AMERICAN SUZUKI MOTOR CORPORATION

07V-362  
(11 pages)

4 - STROKE  
GS/GSX/GSX-R BULLETIN NO. 172  
DATE: 8/16/2007

**SAFETY RECALL CAMPAIGN #2098  
ALL 2007 GSX-R1000K7 MODELS  
IDLE SPEED CONTROL VALVE REPLACEMENT**

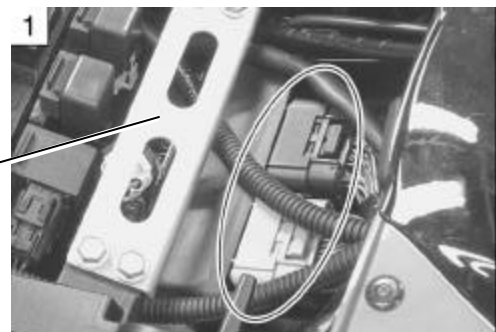
4. Remove and replace the ISC valve. (Refer to Service Manual, Page 5-25)

NOTE: Since the ECM is also being replaced there is no need to perform the ISC valve pre-set operation.

Carefully insert the ISC valve straight into the throttle body hole to prevent damaging the o-ring. Turn the ISC valve slightly to confirm that the o-ring has not twisted. Using the new screw provided in the replacement parts kit, make sure the screw is completely seated on the plate after the screw has been tightened to the specified torque.

### **🔧 ISC Valve Mounting Screw Torque: 2.1±0.6 N.m (1.5±0.4 lb-ft)**

Upper seat rail plate

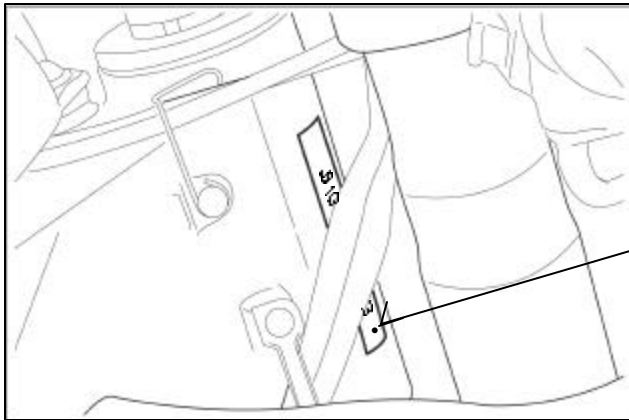
5. Install the air cleaner box in reverse order of removal. (Refer to Service Manual, Page 5-14)
6. Lower the fuel tank. (Refer to Service Manual, Page 5-3)
7. Remove the upper seat rail plate.  
Disconnect and remove the ECM. (Figure 1)

8. Install the new ECM in reverse order of removal.

Apply thread lock to the upper plate mounting bolts when reinstalling the upper seat rail plate.
